# Access Compliance Report

## Public Rights-of-Way

Intersection ID: N/A	Main Street: JOHN_BELK_RA	Cross Street: S_CALDWELL_ST	Location: SW
ADA ID: A226798B1927	Ramp Type: Perp	Initial Pass/Fail: Fail	Overall Compliance: No
		Severity Score: 25

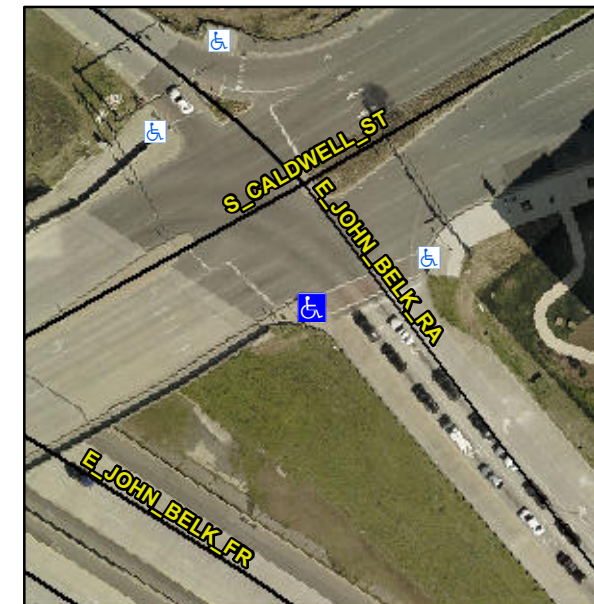
**Not Found, R304.2.2, R304.5.3**

Compliance	Description	Data	Compliance	Description	Data
N/A	Ramp Length (in)	94.0	No	Ramp Slope (%)	9.9
Yes	Ramp Width (in)	48.0	No	Ramp XSlope (%)	5.9
N/A	Flare Type LT	N/A	N/A	Flare Type RT	N/A
N/A	Flare Slope LT (%)	N/A	N/A	Flare Slope RT (%)	N/A
N/A	Flare Traversable LT?	No	N/A	Flare Traversable RT?	No
N/A	Landing Length (in)	N/A	N/A	DWS Provided?	N/A
N/A	Landing Width (in)	N/A	N/A	DWS Contrast?	N/A
N/A	Landing Slope (%)	N/A	N/A	DWS Length (in)	N/A
N/A	Landing X Slope (%)	N/A	N/A	DWS Full Width?	N/A
N/A	Landing Curb? (Y/N)	N/A	N/A	DWS Offset (in)	N/A
N/A	Shared Landing?	N/A			
N/A	Gutter Ponding?	N/A	N/A	Gutter Slope (%)	N/A
N/A	Gutter Lip Ht (in)	N/A	N/A	Gutter X Slope (%)	N/A
N/A	Painted X Walk1?	Yes	N/A	Painted X Walk2?	N/A
	X Walk 1 Direction	To E		X Walk 2 Direction	N/A
N/A	X Walk 1 Width (in)	127.0	N/A	X Walk 2 Width (in)	N/A
	X Walk 1 Slope (%)	2.9		X Walk 2 Slope (%)	N/A
	X Walk 1 X Slope (%)	1.2		X Walk 2 X Slope (%)	N/A

**Remove & Replace Entire Ramp.**
